SUBJECT: TECHNICAL REVIEW OF FINAL INVENTORY  
DOCUMENTATION FOR TANK 16H at SAVANNAH RIVER SITE  
(DOCKET NO. PROJ0734)

## **Technical Review of Final Inventory Documentation Supporting Tank 16H Closure**

**Date:** October 28, 2015

**Figure 1 Visual Evidence of Annular Waste Heights Near Station 10+00 (Reproduced from Figure 10 U-ESR-H-00113).**

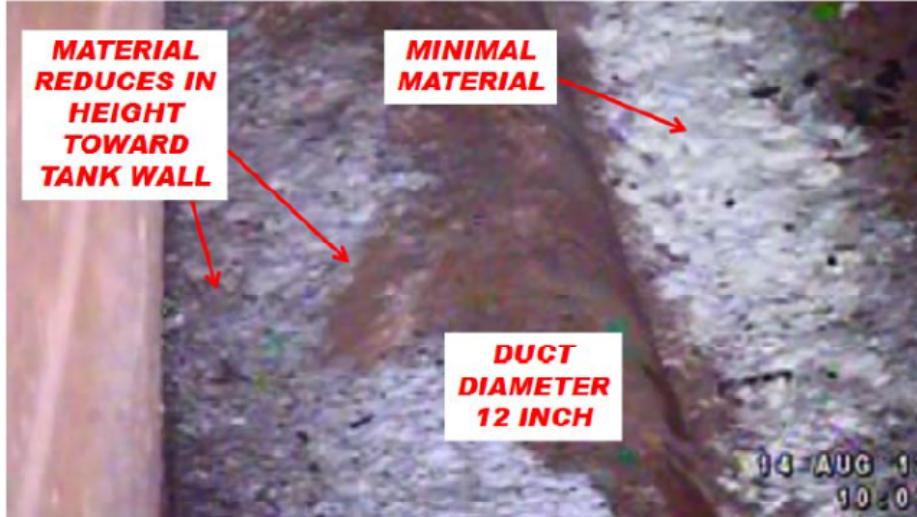
During the July 2015 on-site observation, the DOE clarified that it generally relied on measured values of waste heights to develop the annular inventory and visual evidence was used to confirm or deny the plausibility of measured values. Visual evidence was also used when interpolating solids heights between sampling locations. However, in most cases, the DOE used simple interpolation methods to assign waste heights between measured values and rarely used visual evidence to adjust heights between areas that were not measured. While the visual data appeared to be at odds with the interpolated data in some instances, the DOE's methods are reasonable and appear sound in most cases. However, in certain limited cases, the arguments do not appear to be supported. For example, the DOE indicates in U-ESR-H-00128 the following (Figure 10 referred to in the text is reproduced below for ease of reference):

*"STA 10+00 is an area between two measured values of 2 inches and 5.5 inches. Visual evidence suggests that the solids height did not increase between the two sample locations, therefore the value at STA 10+00 would 5 inches or less. There is a minimal amount of material to the right side of the duct, material is coating the left side of the duct, then the material appears to decrease in height away from the duct to the left (Figure 10). Several data points were used to assign a value:*

*The interpolated height from the nearest measured heights (3 inches) was assigned for this area, and evaluation of visual evidence did not result in adjustment to the interpolated height. Visual depth perception was a factor in the decision to not adjust the interpolated height. A photo of the area is included below (Figure 10)."*

The photographic evidence clearly shows waste near the top of the annulus duct at 12 inches on the primary liner side of the duct; however, the assigned height in this area is 3 inches based primarily on interpolation between nearby measured values. While the surface along the radius varies, the DOE assigns a single height at each location. This example shows the DOE's reluctance to increase the volume based on visual evidence due to such issues as depth perception. This reluctance appears warranted if the measured values are more certain and visual evidence is less compelling. In this example, the visual evidence that waste is at the top of the known landmark on the primary liner side appears to be compelling to the NRC staff.

This example also illustrates the difficulty in use of visual evidence in assigning waste heights, an approach that is commonly used in assigning volumes in the primary liner, as discussed further below.
